Rezoning Transportation Analysis

Petition Number: #2021-120

General Location Identifier: 09503403

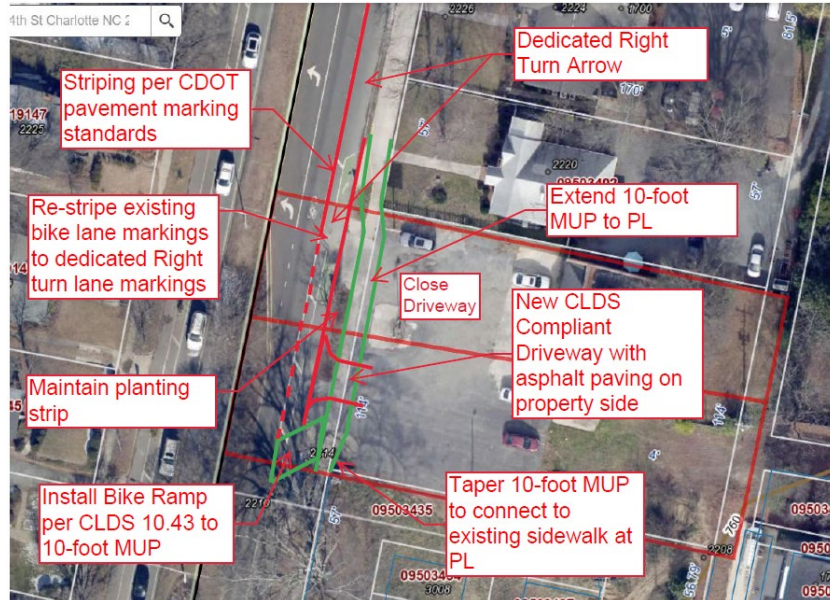
7. ~~Comment from 9-28-22:~~ Revise site plan and conditional note(s) to commit to remarking pavement markings and building a bike ramp near south property line to transition bicyclists from separated bike lanes to multi-use path.

Updated Comment 10-26-22: After further coordination the above design has been updated as follows to. Revise site plan and conditional note(s) to commit to remarking current bike lane pavement markings to a dedicated right turn lane, a bike ramp near south property line per CLDSM 10.43 to transition bicyclists from separated bike lanes to multi-use path and extending the 10-foot multi-use path to the southern property.
